## CITY of NOVI CITY COUNCIL

Agenda Item 1  
July 7, 2014

**SUBJECT:** Consideration of a request from Mirage Development, LLC for a variance from the following ordinance sections: 1) Subdivision Ordinance Section 4.05(A) requiring that pedestrian safety paths be constructed along both sides of local streets (a sidewalk on only the north side is proposed), 2) Section 11-94(c) to provide less than three feet of cover for storm sewer pipe, 3) Section 11-194(a)(7) for exceeding the 800 foot maximum length of a cul-de-sac (975 feet is proposed), 4) Section 11-194(a)(19) for the lack of a secondary or emergency access; as part of the site plan for Orchard Hills North single family residential development (parcel 22-26-201-006).

**SUBMITTING DEPARTMENT:** Department of Public Services, Engineering Division <sup>RH</sup> <sub>RLC</sub>

ORCHARD HILLS NORTH CONDOMINIUM  
PART OF THE N.E. 1/4 OF SECTION 26,  
T.1 N., R.8 E., CITY OF NOVI,  
OAKLAND COUNTY, MICHIGAN

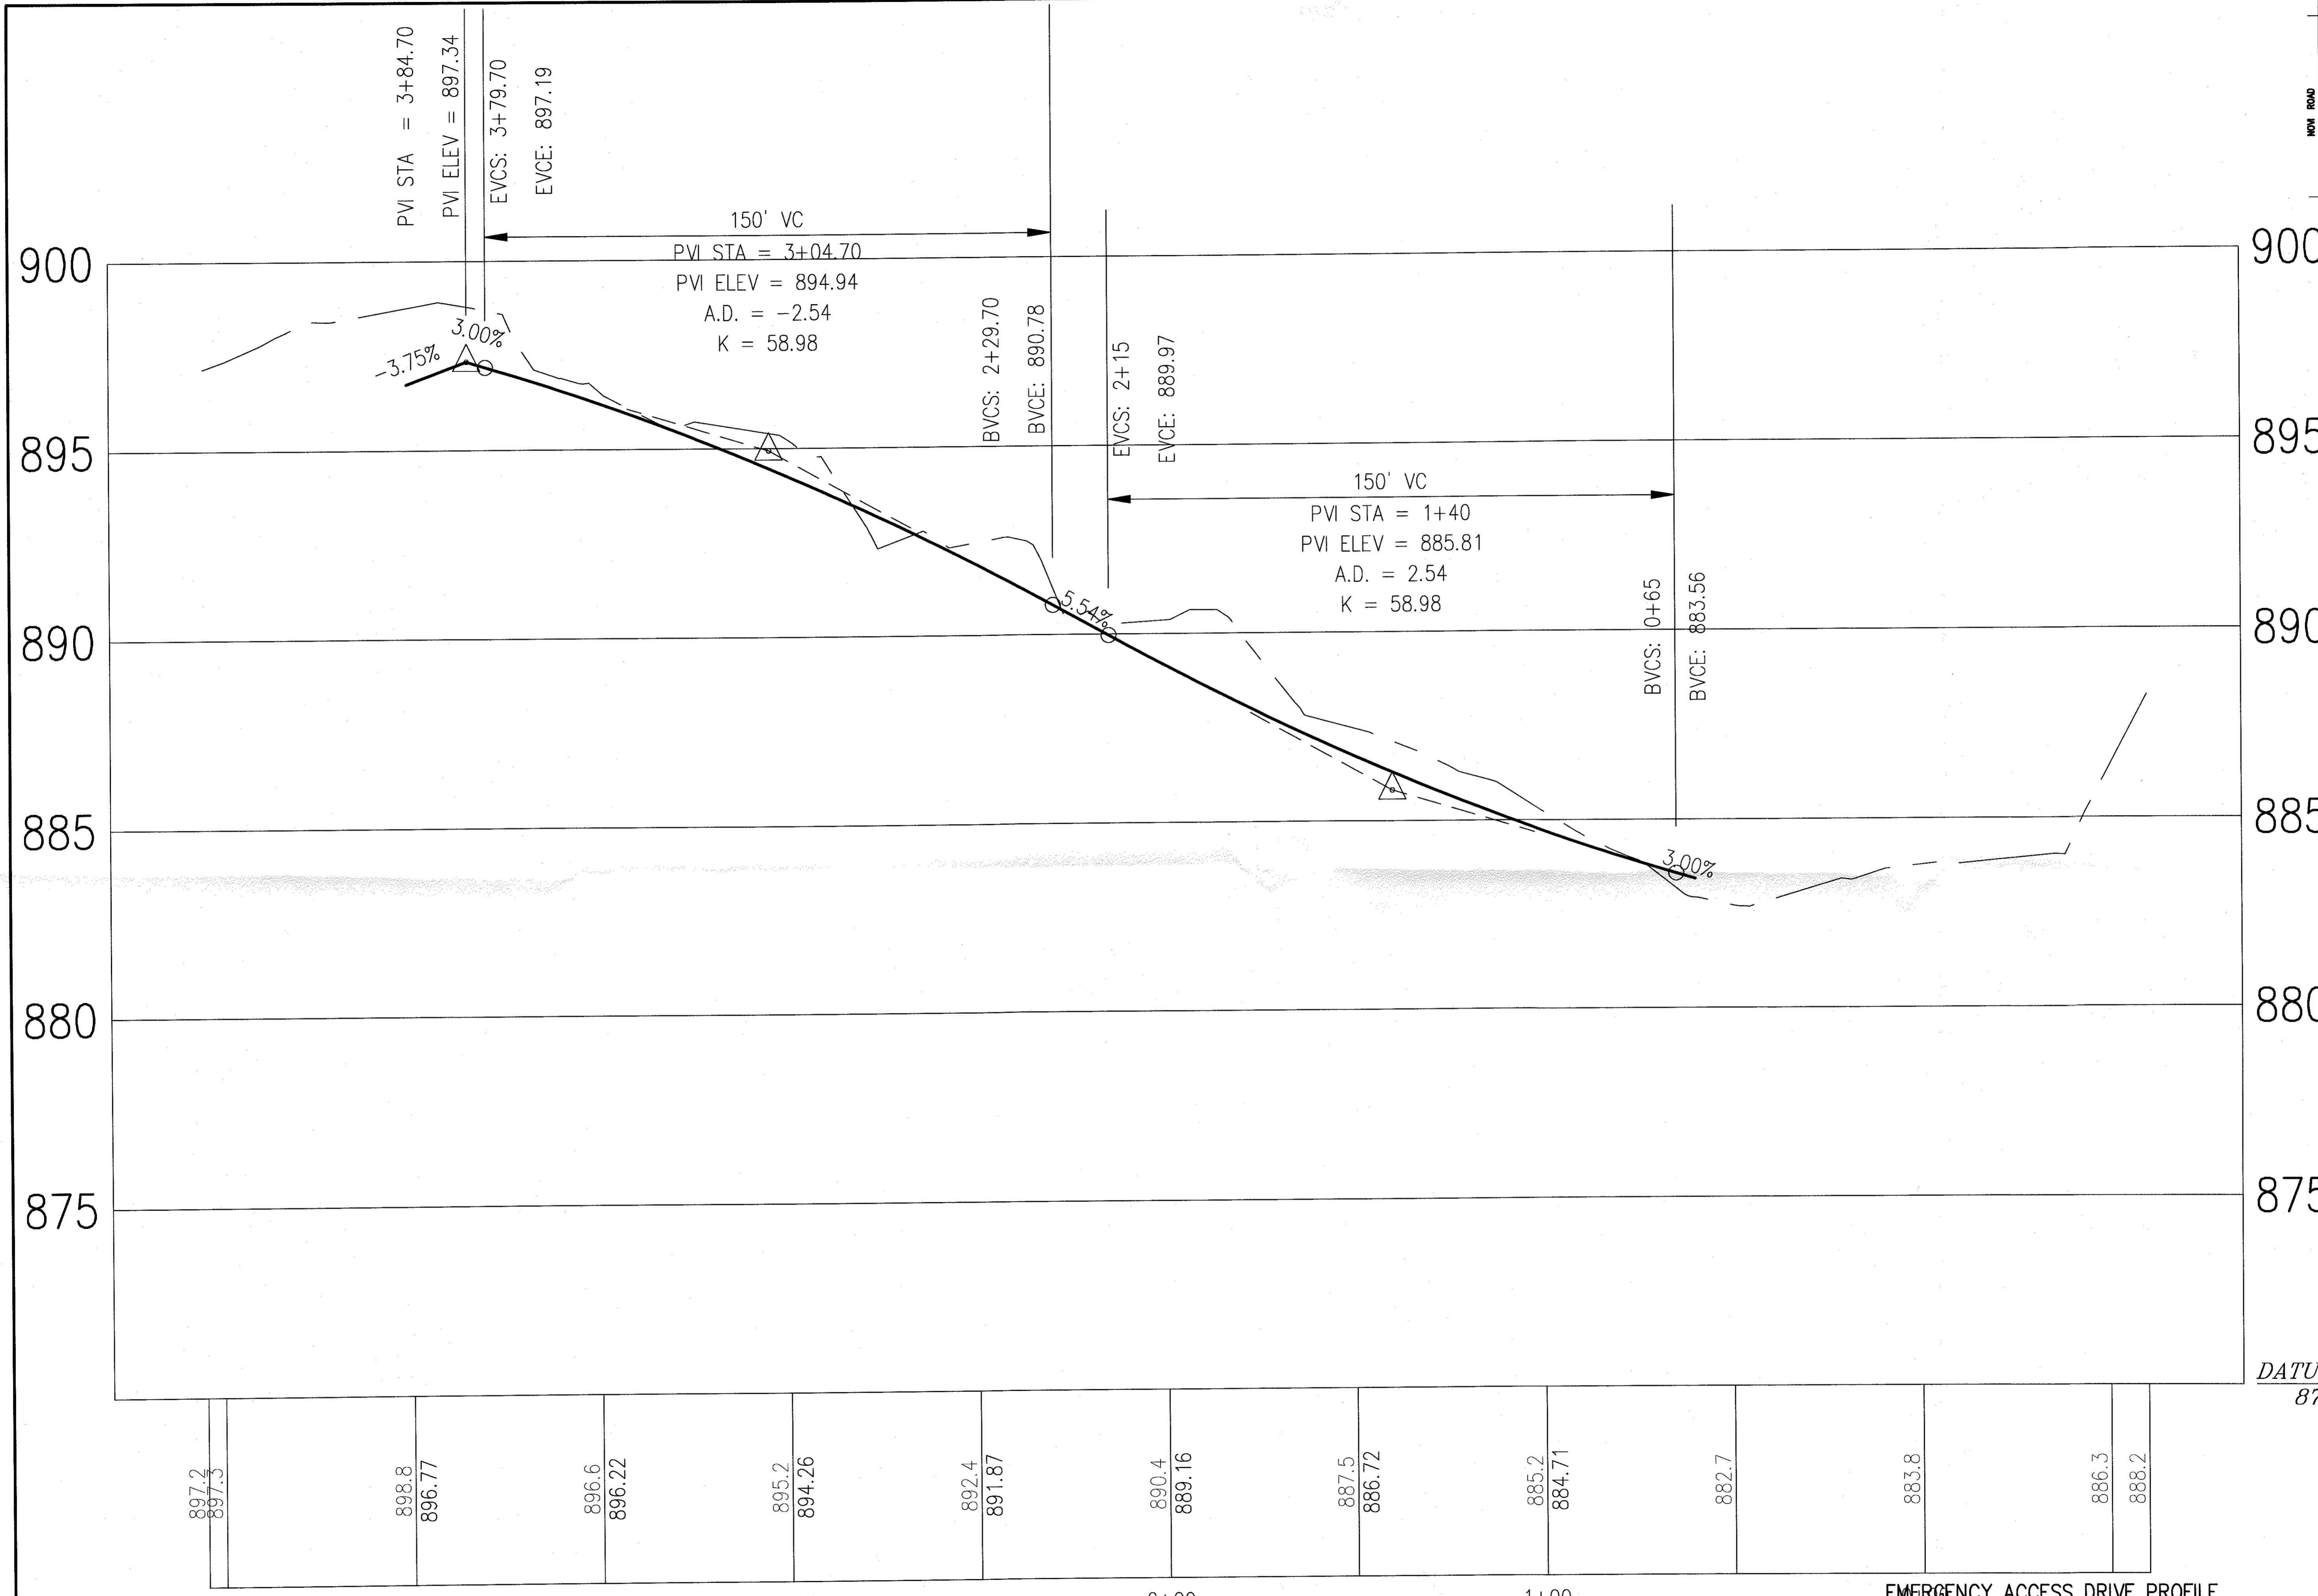
In Mr. Hirth's letter and drawings on June 16<sup>th</sup> provided an explanation to demonstrate that each option from the June 4<sup>th</sup> meeting had been explored and exhausted. The financial and practical impact was stated as well. Mr. Hirth pointed out three more bullet items to explain the exceptional and practical difficulty in providing the secondary access. That the project has a reduced number of 12 units proposed, roughly 50% less than what is allow by zoning and a final statement regarding the variance would not be detrimental to the public health, safety, or welfare. I spoke to Mr. Rossi on June 25<sup>th</sup> as he wanted to make sure we had all the information to review. He also expressed safety concerns about the 7 foot grade of the retention wall should the secondary egress be built.

- Providing an emergency access at the west end of site  
We have prepared a site study of an emergency access to the site; see attached plan. The proposed drive meets Novi's requirement of 18 foot wide paved surface within a 25 foot access easement. Due to the existing cross slope from the west property line to the existing pond (see attached drawing), a retaining wall is required. The retaining wall will vary in height from 0.5 to 7.0 feet.  
The effect on unit 11 is that the home width would be reduced by 10 feet, to 40 feet in width. The builder/developer does not have a house plan for that size house, therefore unit 11 is effectively eliminated.  
One of the council members suggested downsizing the lots in order to pick up the necessary width for an access easement alongside unit 11. This not only would require a variance from City Council, but a revised site plan and the related engineering would have to go in front of the Planning Commission for their approval. This would also

cause the builder/developer to redesign his proposed home plans to meet the reduced unit size. The planned homes have the same footprints he used for Orchard Hills West. The cost of redesigning the house plans and the cost of retraining his work force, including working out the “bugs”, is a practical difficulty for only 11 homes. Therefore, the costs to build the access drive, construct the retaining wall, and the loss of unit 11, make the secondary access an exceptional hardship.

ORCHARD HILLS NORTH CONDOMINIUM  
PART OF THE N.E. 1/4 OF SECTION 26,  
T.1 N., R.8 E., CITY OF NOVI,  
OAKLAND COUNTY, MICHIGAN

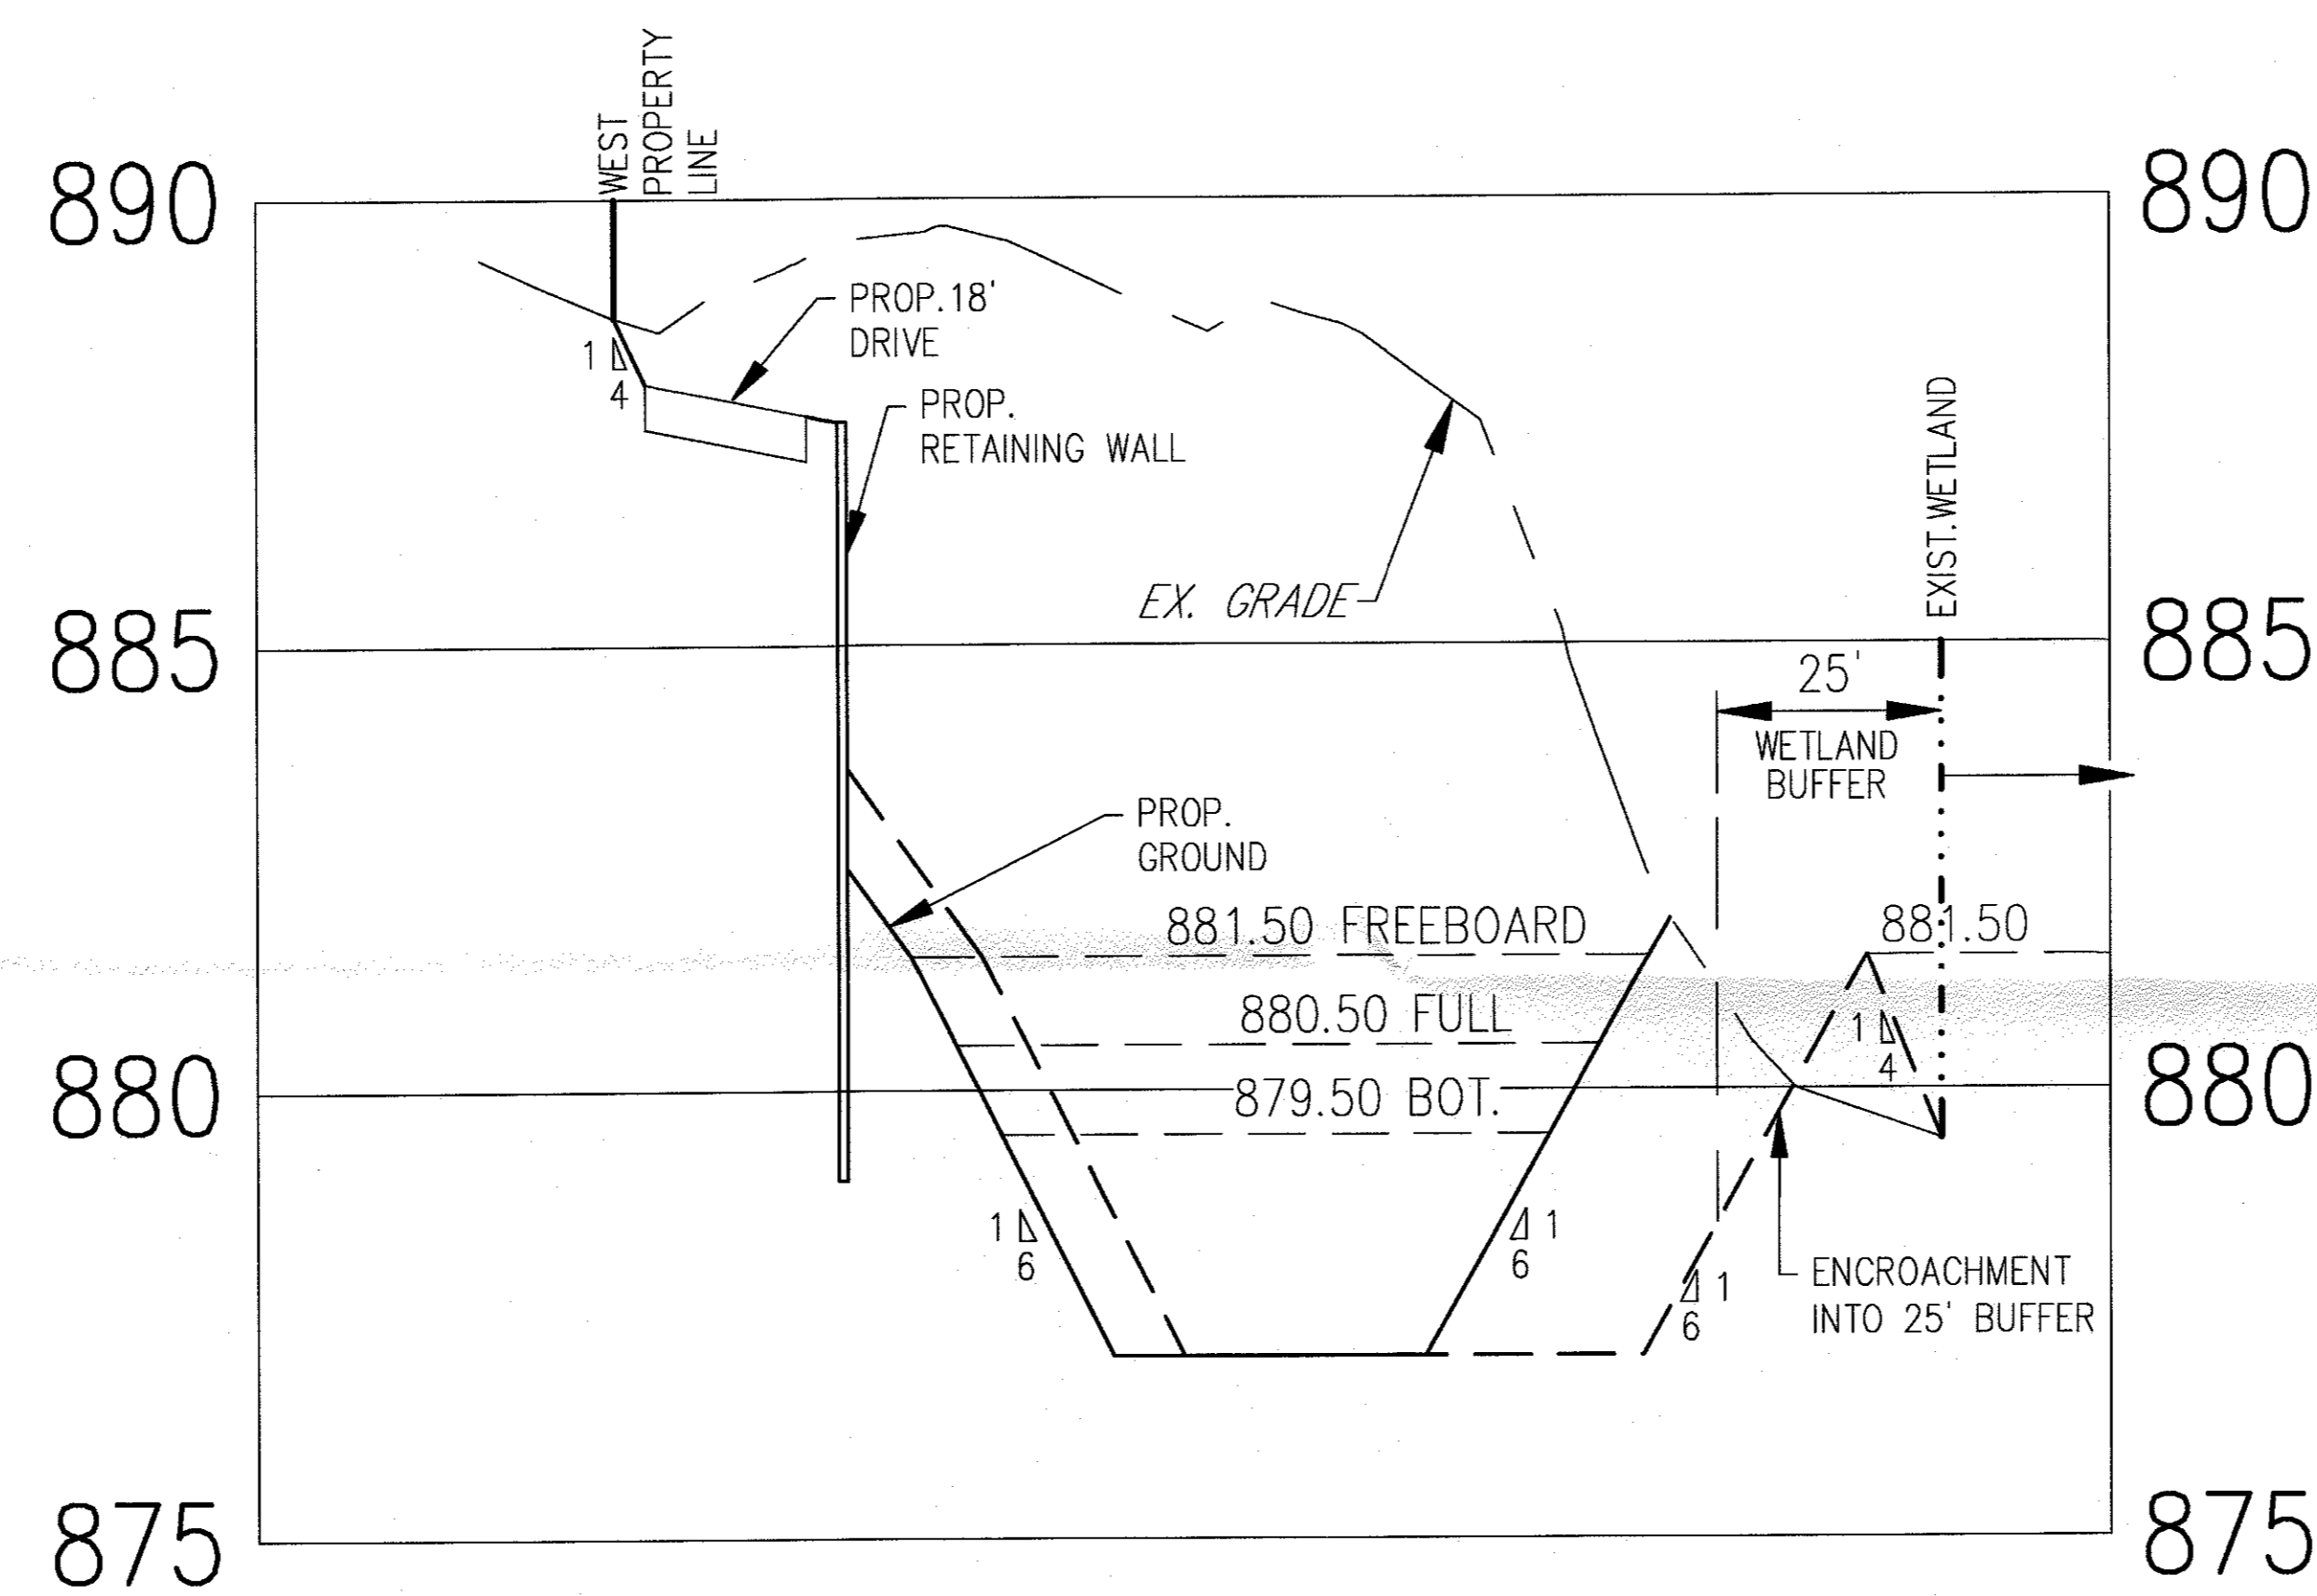
At our meeting we discussed the use of bio swale along the rear yards of units on the north side of Woodglen Drive, in lieu of the sediment forebay/water quality basin, to eliminate the need for a retaining wall along the emergency access drive. The practical difficulty of the use of bio swales on single family lot/units is that maintenance and care of the specialized vegetation required to make them effective, is not under unified control. Single family home owners typically install and maintain landscaping features on their units, which makes consistent plantings and maintenance difficult. Bioswales are very similar to miniature wetlands. They are mostly wet swampy features, which many people would not find aesthetically pleasing; please see the attached.

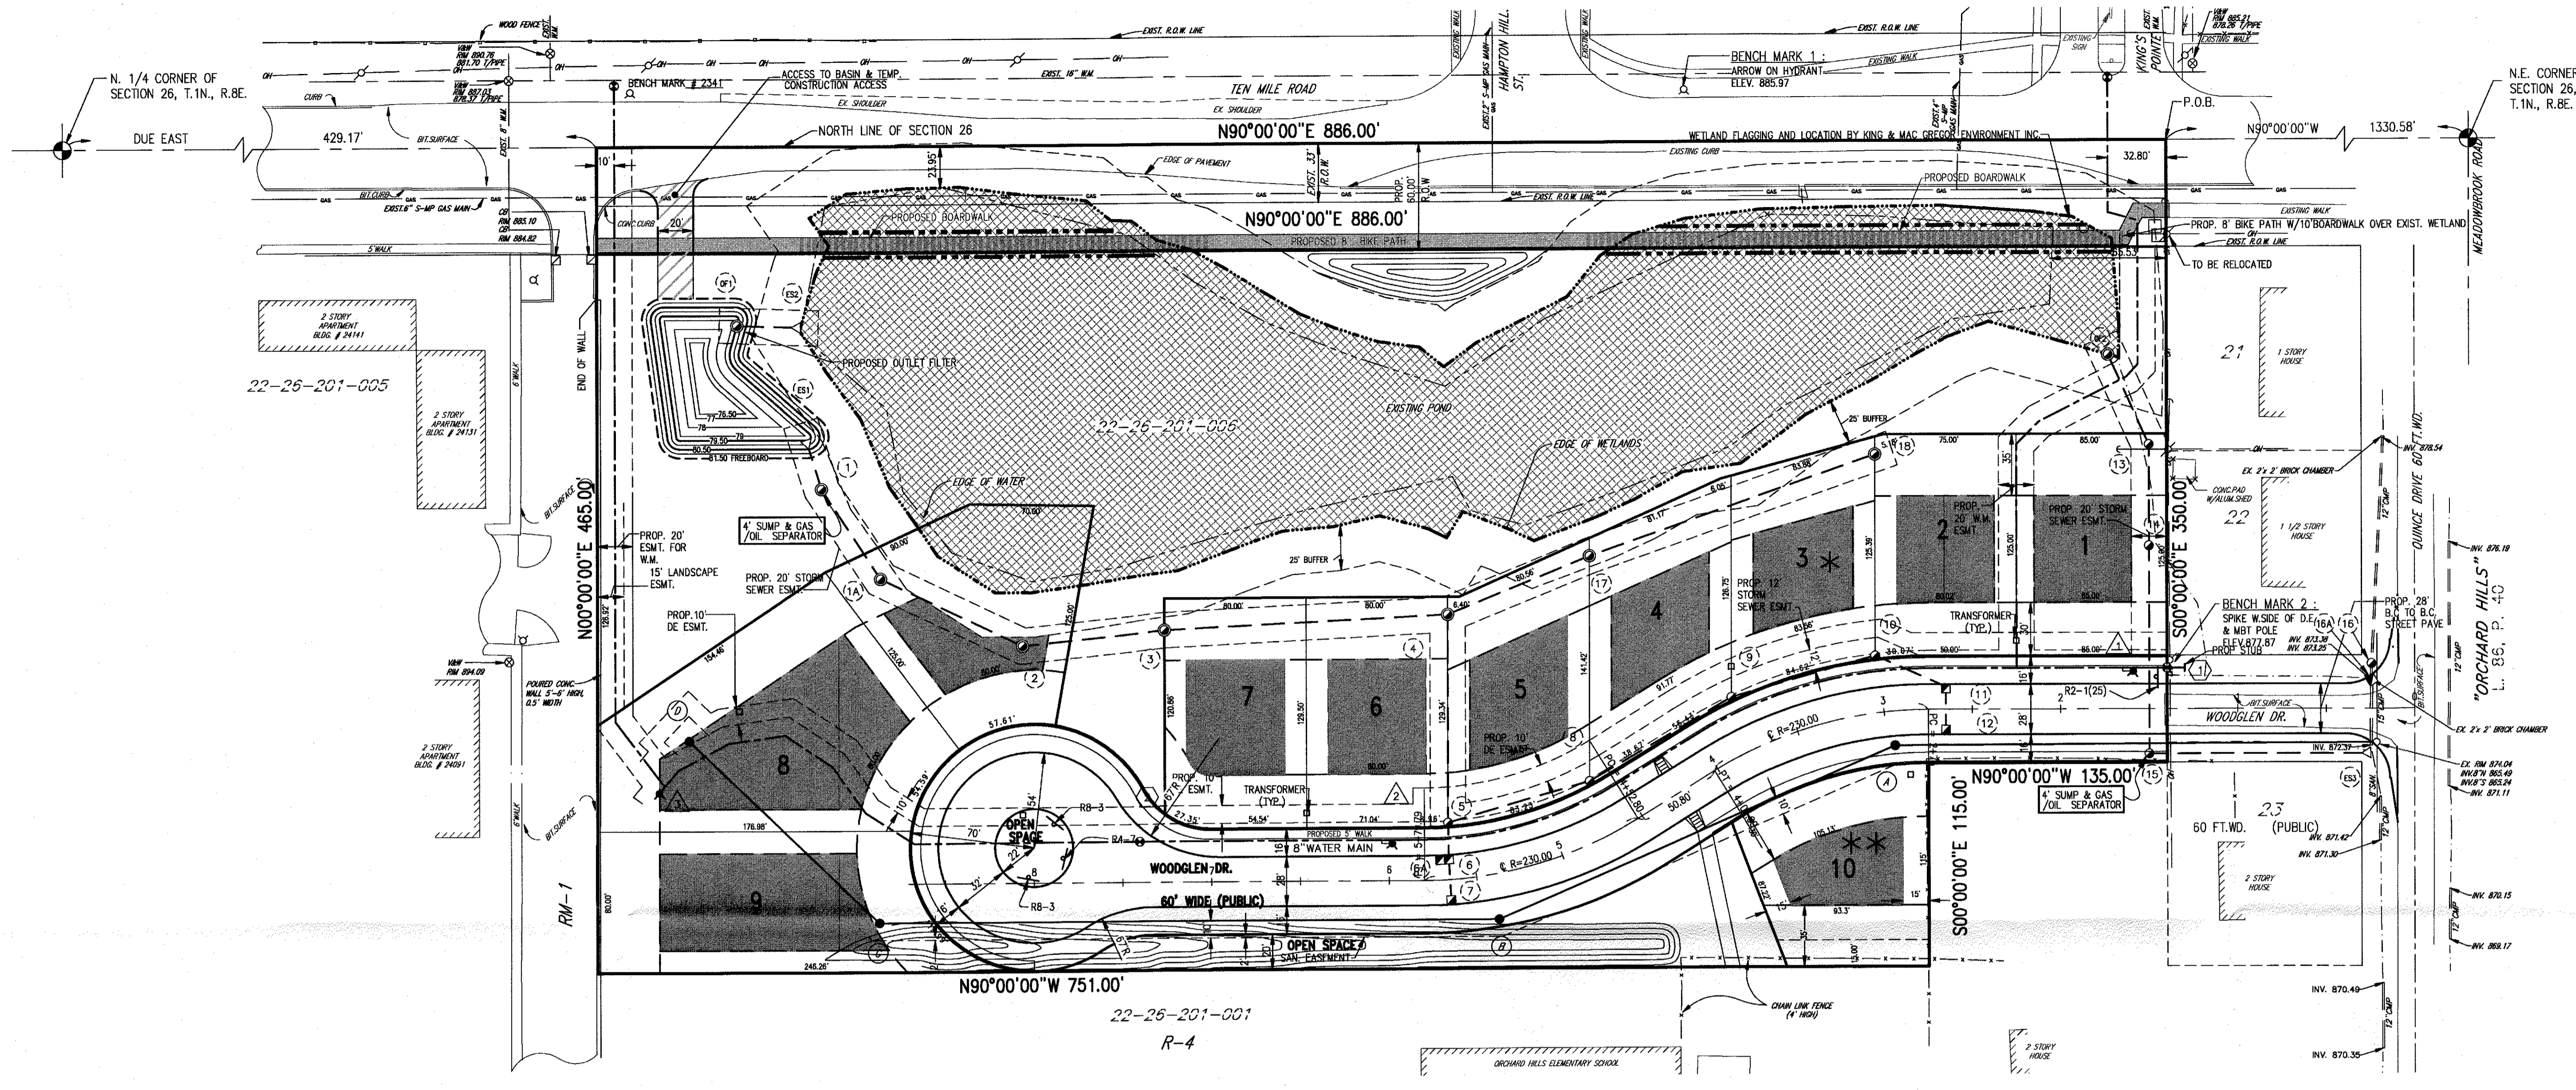
- The reason for this request is that there are several runs of storm sewer which, in order to outlet to the sediment basin, cannot be placed to provide the three feet of minimum cover. Additional fill cannot be placed due to their location and topography.

- The reason for the request is that there are no places to provide external access due to the topographic and natural features of the site. In addition, the property to the west is an apartment complex with private drives and the property to the south is the school. As with the request for exceeding the 800 foot maximum cul de sac length, there will be only 12 proposed units.
